PUBLIC INTEREST REVIEW FOR GROUNDWATER APPLICATIONS

TO: Water Rights Section Date 06/10/2016
 FROM: Groundwater Section Phillip I. Marcy
 SUBJECT: Application G- 18277 Reviewer's Name
 Supersedes review of _____ Date of Review(s)

A. GENERAL INFORMATION: Applicant's Name: David L. Woolfolk/Carman S. Lovell County: Malheur

Water-Level Trends in Nearby Wells

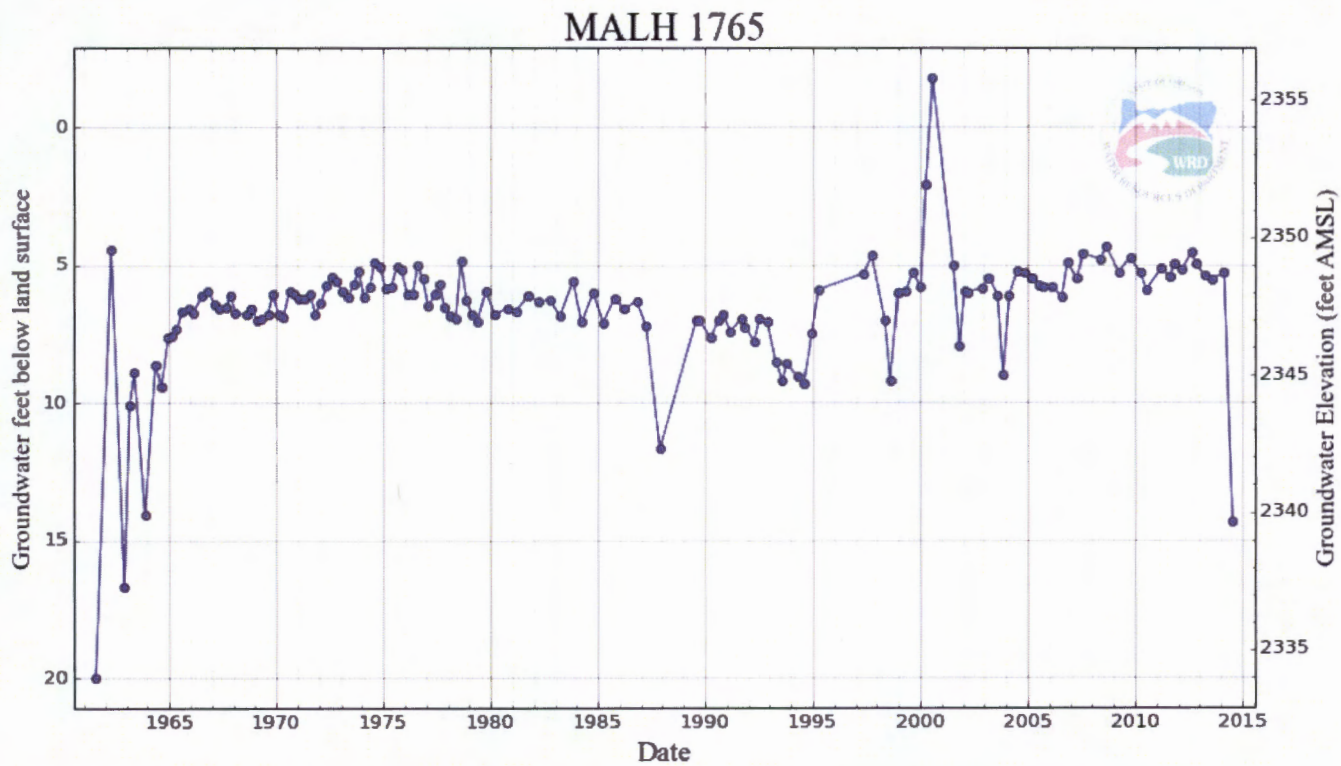
State Obs Well MALH 1765, 4.6 miles to the north of proposed POA MALH 1773, showed about 10 feet of decline during the drought of 2014. MALH 1765 is open to both unconfined alluvium and deeper bedrock lithologies.
